**MEMPHIS AND SHELBY COUNTY OFFICE OF PLANNING AND
DEVELOPMENT
STAFF REPORT**

CASE NUMBER: SUP 10-232 L.U.C.B. **MEETING:** January 13, 2010

REQUEST: Cell Tower – 150’ Tall – Flush Mounted Design

**OFFICE OF PLANNING AND DEVELOPMENT
RECOMMENDATION**

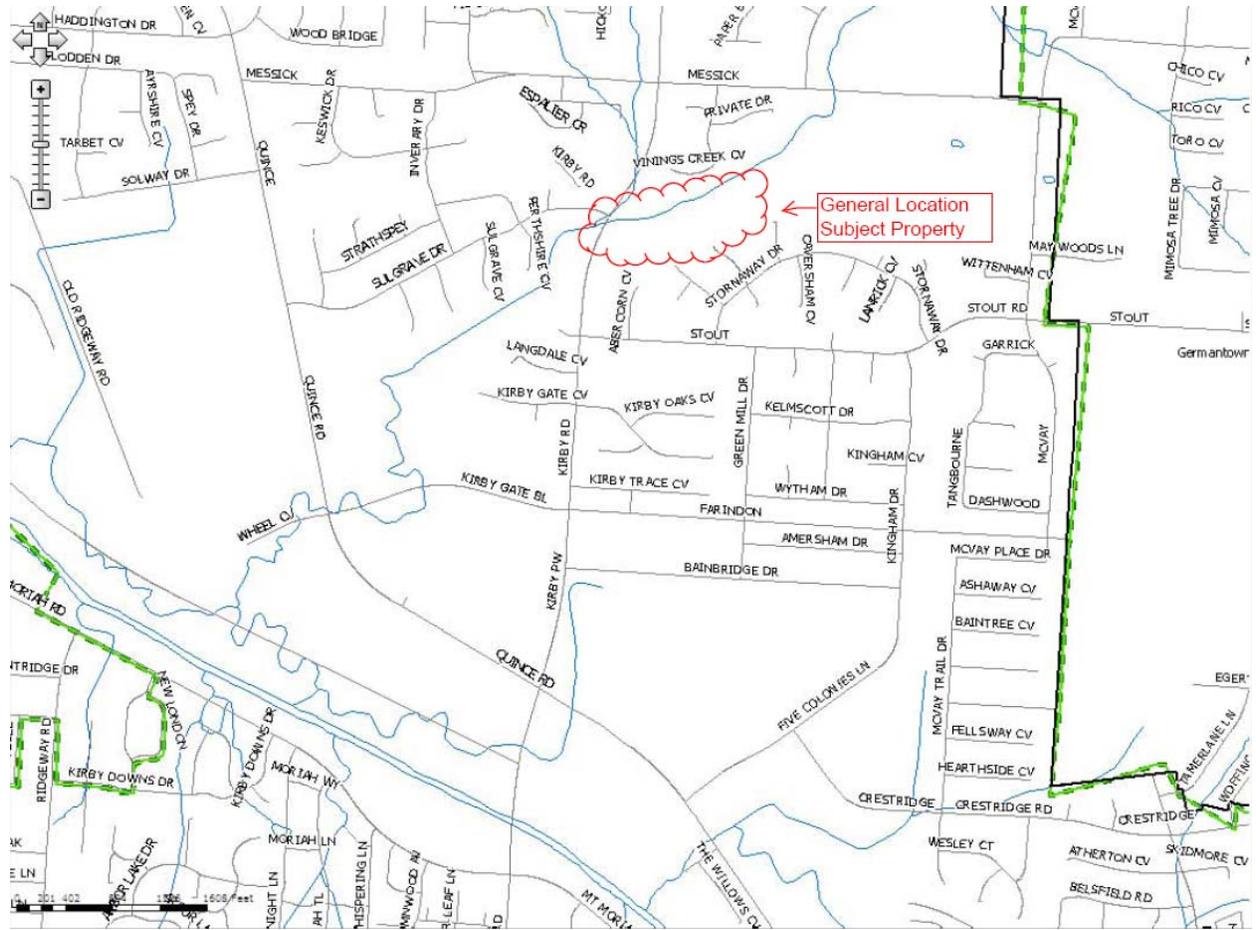
1. While the staff continues to support and encourage the use of existing towers (such as MLGW/TVA Towers), the response of the applicant does indicate an appreciation for the requirements of the ordinance and meets the intent of the requirements.
2. The applicant's placement of the tower and compound on this site is sensitive to the residential neighbors, the location is roughly equal in distance to the north and south property lines. Unfortunately, the physical encumbrances of the site limit the width and type of planting screen that can be used along the compound's southern boundary.

JOB DATA			
Page 1 of 1	Job No.	Q101101002	
By TW	Design No.	M10-0640	
CHK'd By	Date	Nov 2 2010	
	Rev. No.	0	Rev. Date
Structure	150-FT CANISTER POLE		
Ref. No.	...na\2010\10-0600\M10-0640\Q101101002.out		
Design Standard	ANSI/TIA-222-G-2005 Addendum 2

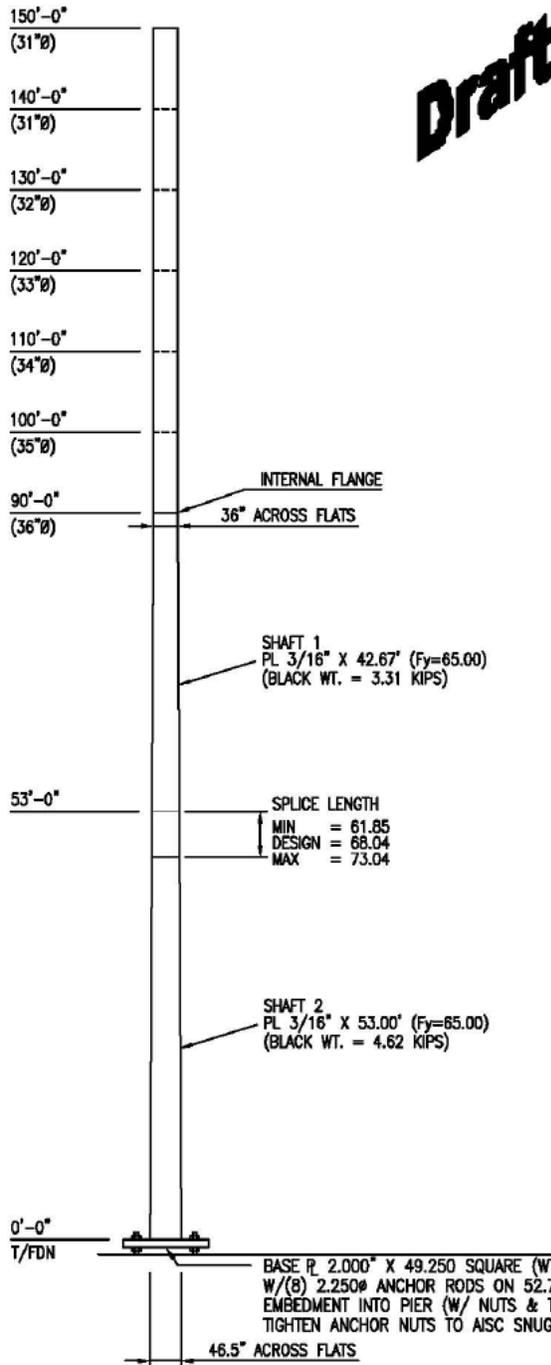
1. The Tower shall be a Flush Mount Design (as shown on the Plot Plan Graphic), maximum height 150 feet tall (height does not include lightning rod).
2. The Tower shall be structurally designed to accommodate at least five additional CMCS sectorized antennas.
